AMENDMENTS TO THE DRAWINGS:

REMARKS

FIG. 5C

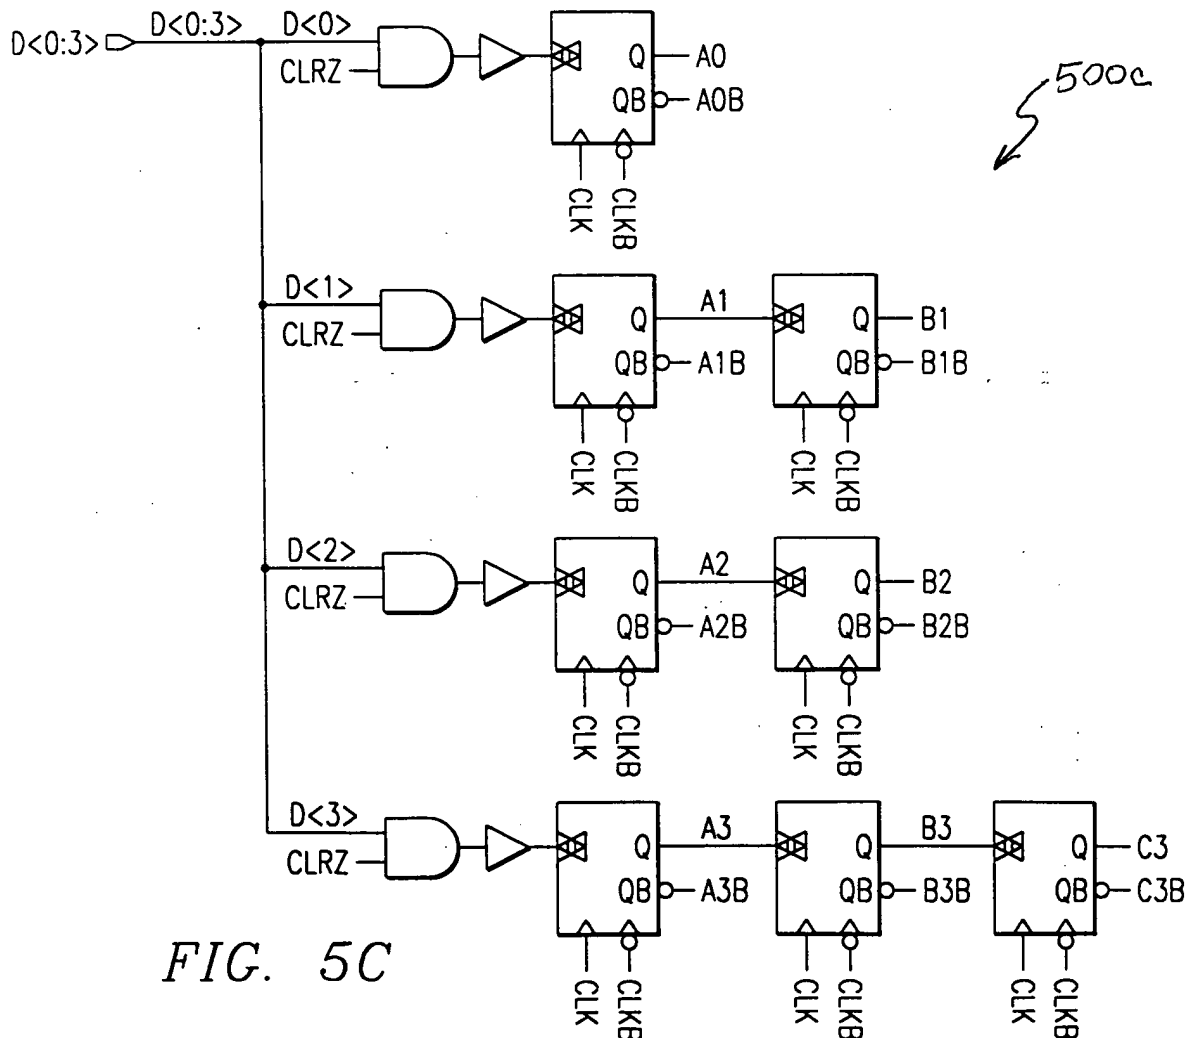
On Sheet 1, in Figure 5C, add the reference --500c-- with an arrow pointing to the circuit.

FIG. 4

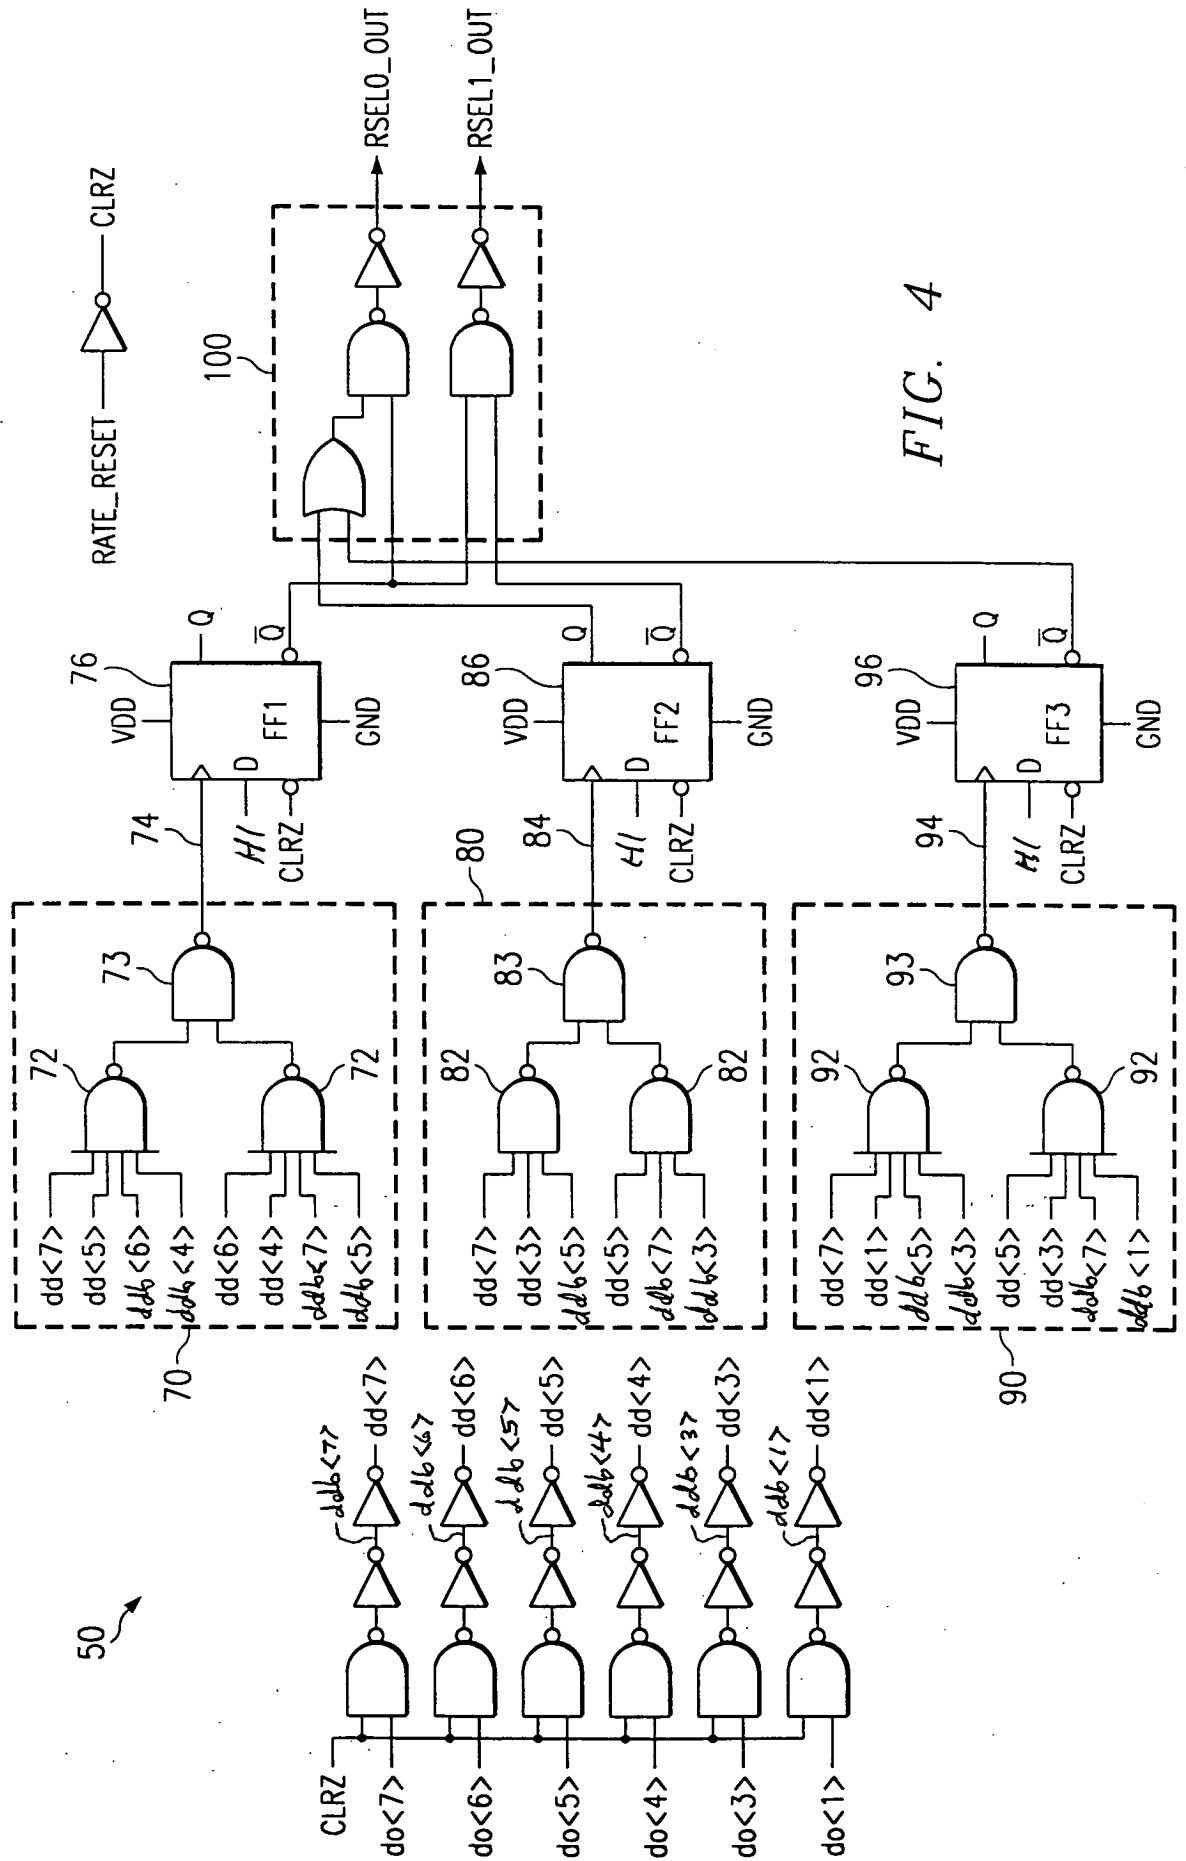
On Sheet 3, in Figure 4:

add --ddb<1>--, --ddb<3>--, --ddb<4>--, --ddb<5>--, --ddb<6>-- and --ddb<7>-- referring to the inputs of the inverters having outputs "dd<1>", "dd<3>", "dd<4>", "dd<5>", "dd<6>" and "dd<7>", respectively;

change "dd<4>" to --ddb<4>-- and "dd<6>" to --ddb<6>-- at the input of the upper NAND gate 72 in dashed box 70;

change "dd<5>" to --ddb<5>-- and "dd<7>" to --ddb<7>-- at the input of the lower NAND gate 72 in dashed box 70;

change "dd<5>" to --ddb<5>-- at the input of the upper NAND gate 82 in dashed box 80;

change "dd<7>" to --ddb<7>-- and "dd<3>" to --ddb<3>-- at the input of the lower NAND gate 82 in dashed box 80;

change "dd<5>" to --ddb<5>-- and "dd<3>" to --ddb<3>-- at the input of the upper NAND gate 92 in dashed box 90; and

change "dd<7>" to --ddb<7>-- and "dd<1>" to --ddb<1>-- at the input of the lower NAND gate 92 in dashed box 90.

FIG. 5A

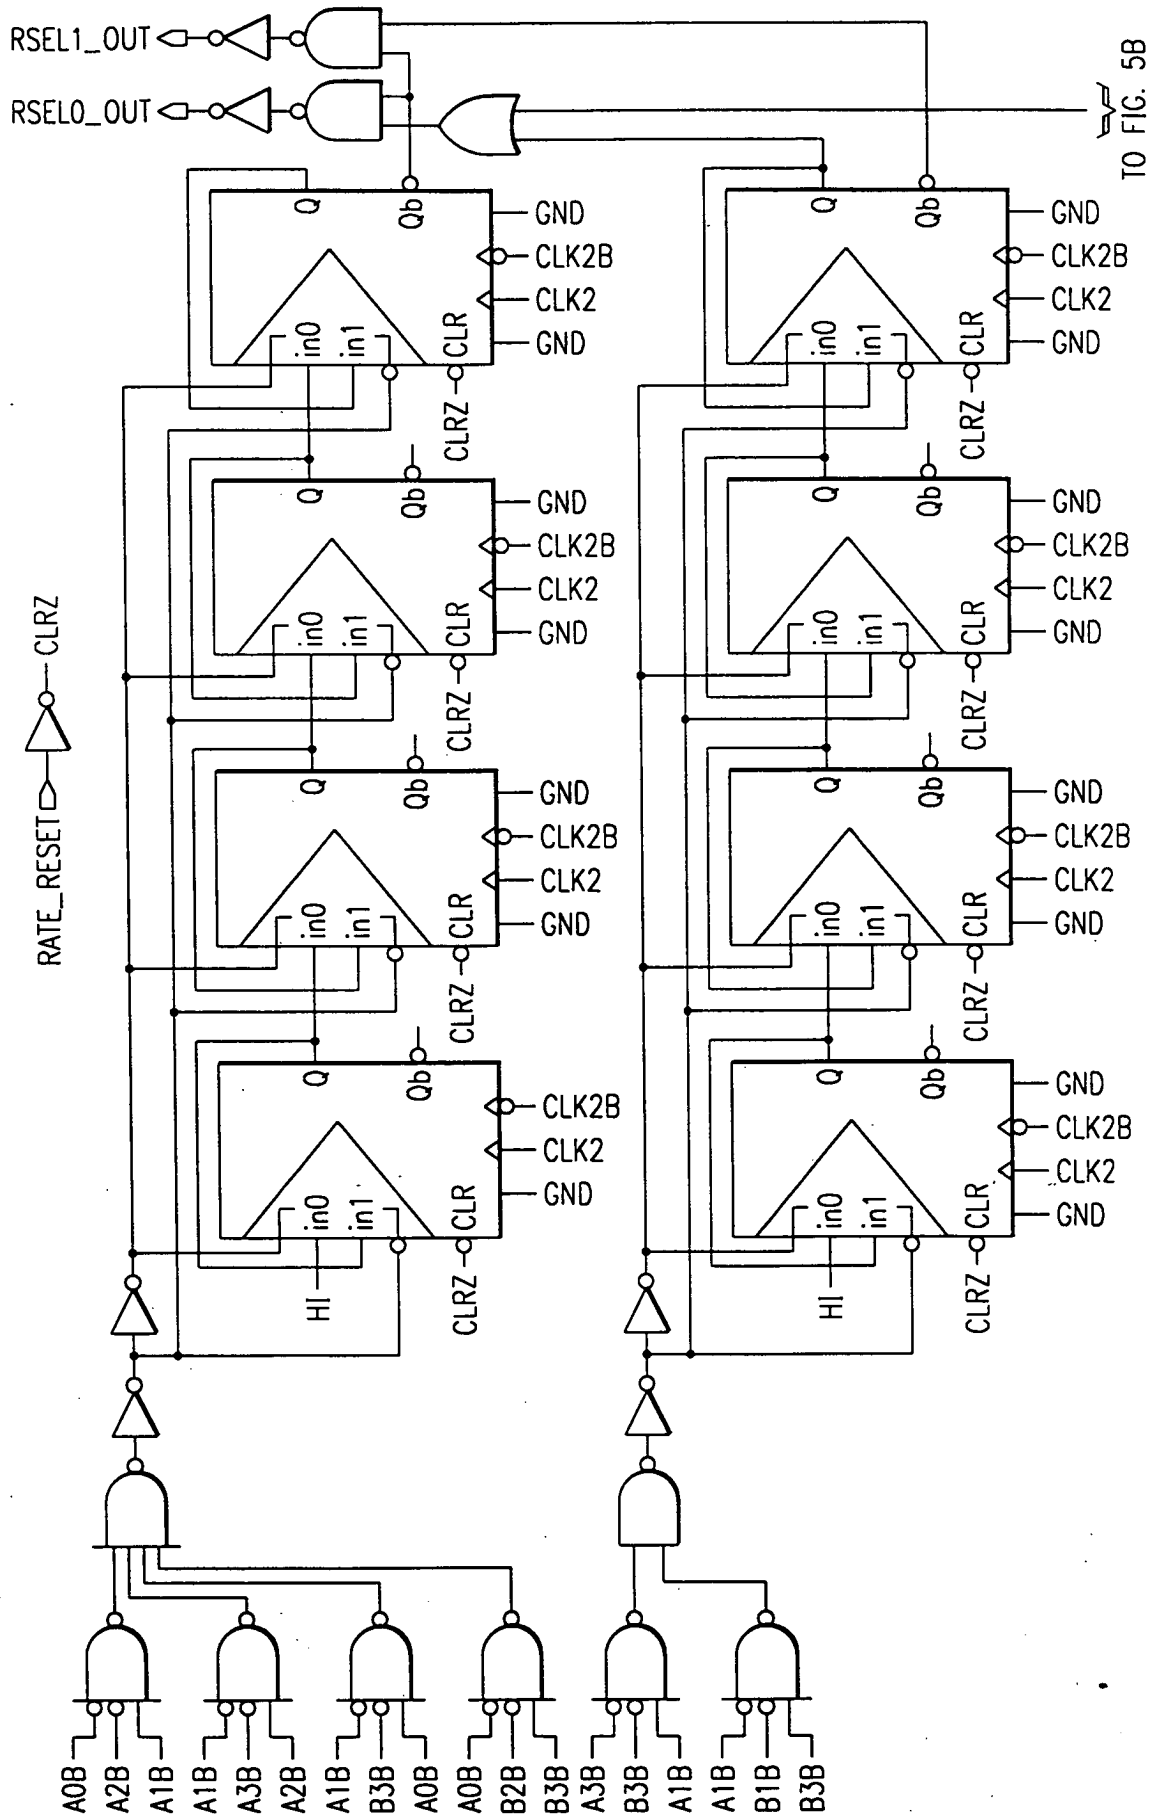
On Sheet 4, in Figure 5A, add the reference --500a-- with an arrow pointing to the circuit.

FIG. 5B

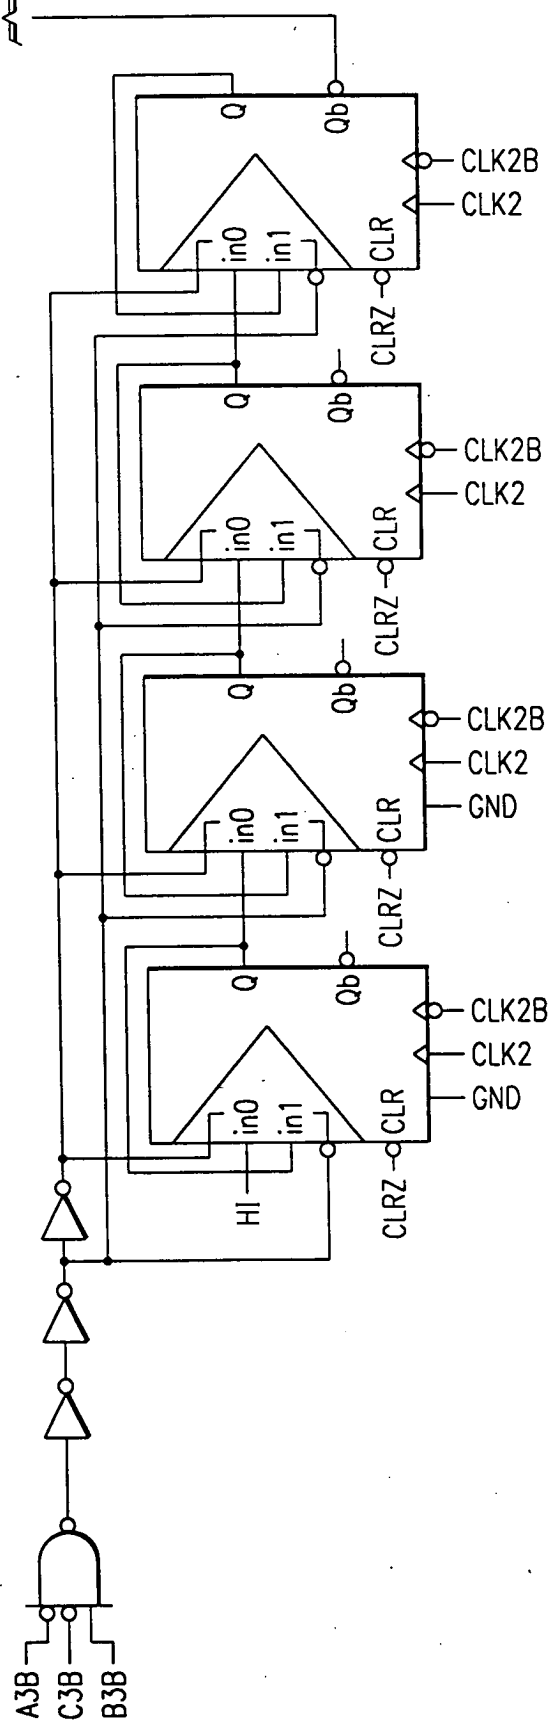
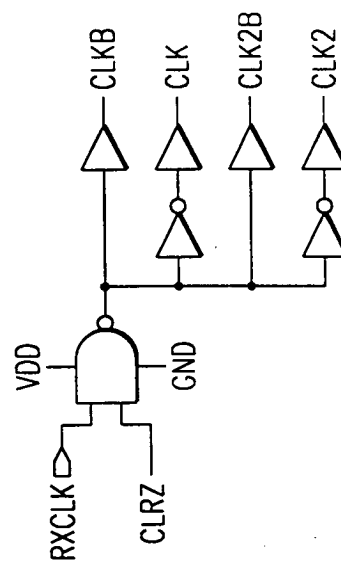
On Sheet 5, in Figure 5B, add the reference --500b-- with an arrow pointing to the circuit.
